## Air Canada Flight 624 Accident, Halifax Nova Scotia, 29 March 2015.

### Accident report critique by Capt. Steve Last

## Air Canada 624 Halifax Accident Report Critique - introduction.

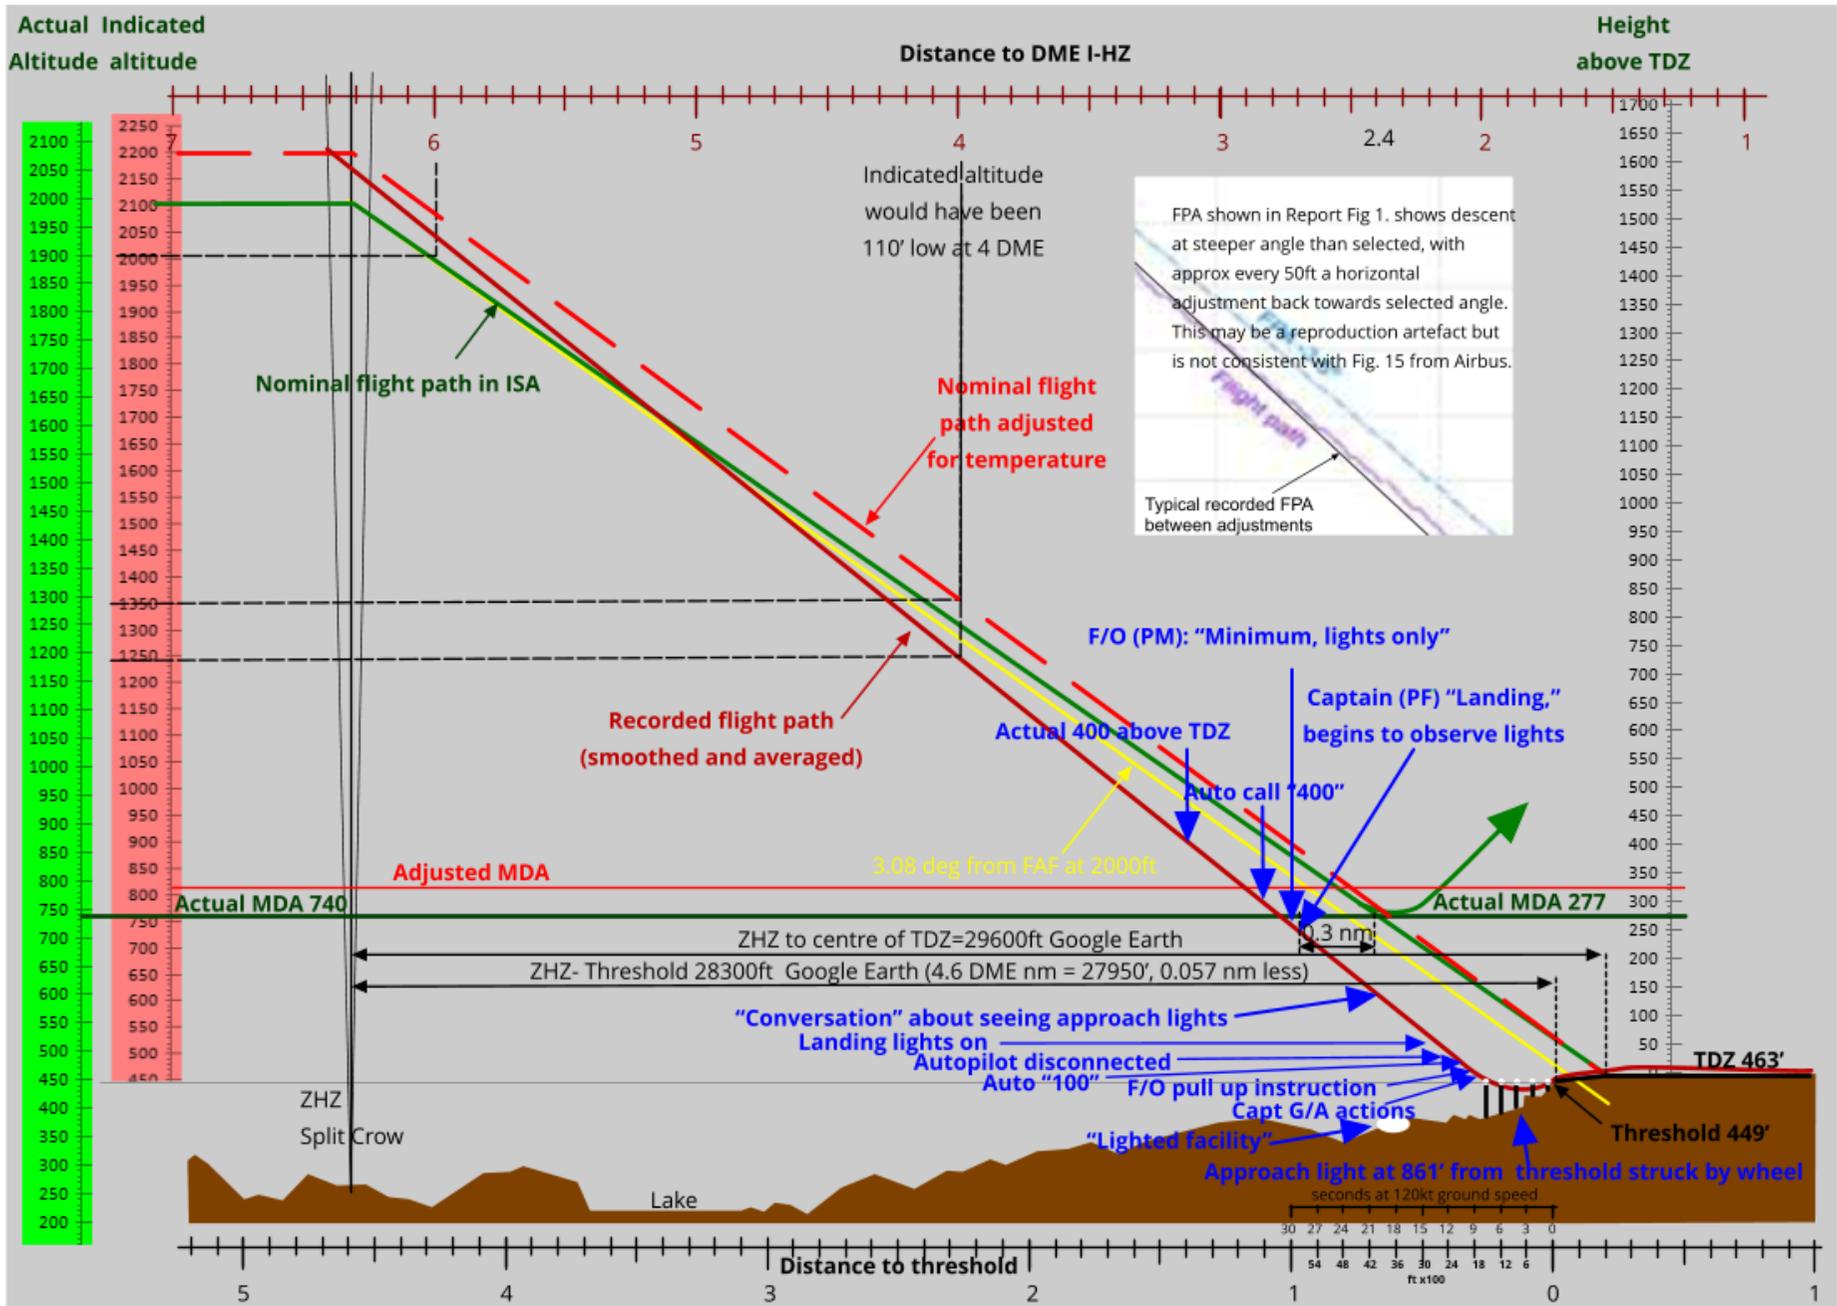
In this accident, none of the pilots' instruments were showing the altitude above the TDZ, which makes it hard to make sense of some of the reported events, so Fig. 1 shows 3 altitude scales.

The Green scale is the ACTUAL height above mean sea level (AMSL). Pink shows what the main altimeters were INDICATING as the height AMSL. The scale on the right shows the actual height above the TDZ, which should have been zero when the aircraft touched down, but was not displayed on any altimeters.

A number of events are shown in blue, the positions are estimates from distances, altitudes or time information in the text or footnotes. The terrain information is obtained from the TSB's press conference presentation correlated with data from Google Earth.

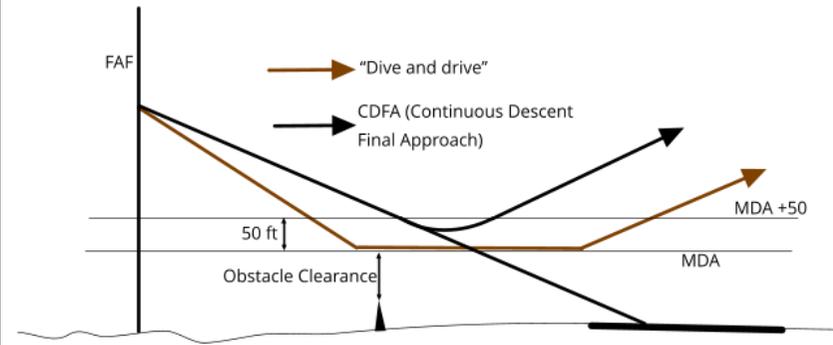
5.	MDA correction	The MDA was calculated at 813 feet ASL, based on the published MDA of 740 feet ASL plus a cold temperature correction of 23 feet, plus 50 feet added to the corrected MDA, as required by Air Canada's <i>Flight Operations Manual</i> (FOM).	The 50ft FOM addition is applied to a Continuous Descent Final Approach (CDFA) which is recommended as safer than a "Dive and Drive" non-precision approach. Adding 50ft to the cold-weather adjusted MDA allows a decision to go-around to be implemented without the aircraft infringing the actual MDA, which assures obstacle clearance. The 50 ft height loss allowance accepts that the aircraft will descend somewhat after the decision is made, as it takes time before the aircraft can respond when the go-around is initiated. With a "Dive

and drive" approach there is no height loss as the aircraft is not descending when the go-around is initiated.

7. Flight Path angle temperature corrections

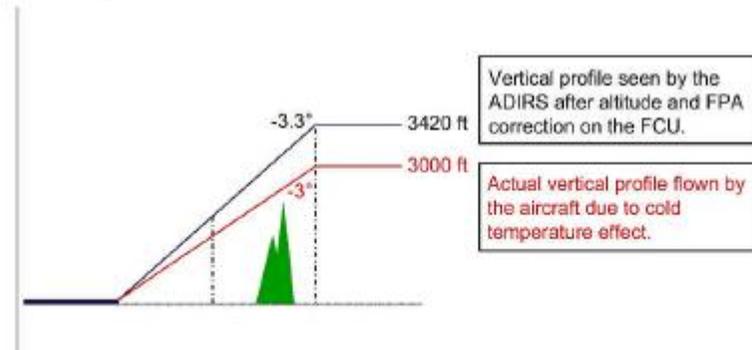
The flight crew calculated a flight path angle (FPA) based on the temperature-corrected FAF. The calculation was based on the published vertical descent angle of -3.08° obtained from the Jeppesen approach chart (Appendix A) and Air Canada's Airbus A320 Quick Reference Handbook for a final calculated FPA of -3.5°.

Airbus FCTM information: "Note: The ADIRS computes the FPA from inertial data and barometric altitude. When the temperature is lower than ISA, the FPA that the aircraft actually flies is less steep than the FPA that the ADIRS (ISA referenced) computes".

The FPA calculation should take the aircraft to the touchdown zone which is about 1000 ft beyond the threshold. In this case the TDZ is 14 ft higher than the threshold so crossing height at the threshold should be about 64 ft .

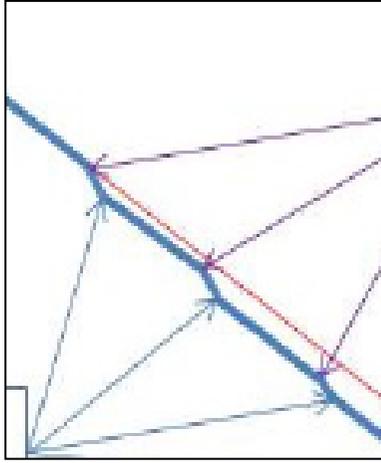
52.	<b>I.18</b>	<b>Additional information</b>	
53.	1.18.2	<p>Flight Path Angle guidance mode</p> <p>When flying with the FPA guidance mode, external perturbations, such as wind variations or turbulence, can cause the aircraft to move away from the selected FPA initial approach path. If these perturbations result in momentary changes to the aircraft's vertical trajectory, then the autopilot will recover the selected FPA, effectively paralleling the initial trajectory</p>	<p>It is understood that Airbus uses the calculation <math>FPA = \arctan(V_{zbi}/GS)</math>, where <math>V_{zbi}</math> = baro-inertial Vertical Speed (inertial for accuracy in dynamic manoeuvres &amp; barometric for stability in time) and <math>GS</math> = Groundspeed. <math>V_{zbi}</math> is computed from <math>V_{acc}</math> (Vertical acceleration from IR), <math>H_i</math> (Inertial altitude from IR) and <math>H_b</math> (Baro altitude from ADR).</p> <p>Report Fig.15 (below left) illustrates the "perturbations" as described by Airbus, showing downward steps away from the initial selected FPA, followed by longer sections returning parallel to it. The printed trace in report Fig 1 (below right) is poor quality but shows the perturbations recorded, which has long sections where the "best fit" lines for the actual flight consistently DIVERGE from the selected FPA, with short horizontal steps back towards it. Without a full FDR readout and knowledge of the FPA algorithm which includes both barometric and inertial inputs, it is impossible to tell what was happening. However, given that no information whatever is provided on the winds experienced during the descent, "external perturbations such as wind variations or turbulence" does not explain the actual</p>

<p>flight path.</p> <div style="display: flex; justify-content: space-around;">   </div> <p>Airbus (Fig 15)</p> <p>Report (Fig 1)</p>
54.	I.18.3	Cold temperature correction	<p><i>The FCTM section reads</i></p> <p>"Note: The ADIRS computes the FPA from inertial data and barometric altitude. When the temperature is lower than ISA:</p> <ul style="list-style-type: none"> <li>- The true altitude of the aircraft is lower than the altitude that the ADIRS computes.</li> <li>- The FPA that the aircraft actually flies, is less steep than the FPA that the ADIRS computes.</li> </ul> <p>If appropriate, the flight crew should therefore apply corrections on the altitudes and on the FPA (in vertical selected FPA mode), and they should be vigilant on the parameters that are displayed.</p> <p>FPA Correction</p> <p>When the temperature is lower than ISA, the FPA that the aircraft actually flies is less steep than the FPA that the ADIRS (ISA referenced) computes.</p> <p>In vertical selected mode FPA, to correct the FPA for this ISA deviation effect, the flight crew should select on the FCU a FPA slightly different from the FPA that the aircraft needs to fly.</p> <p>In any case, the check "altitude (corrected in temperature) versus distance" remains the reference.</p>
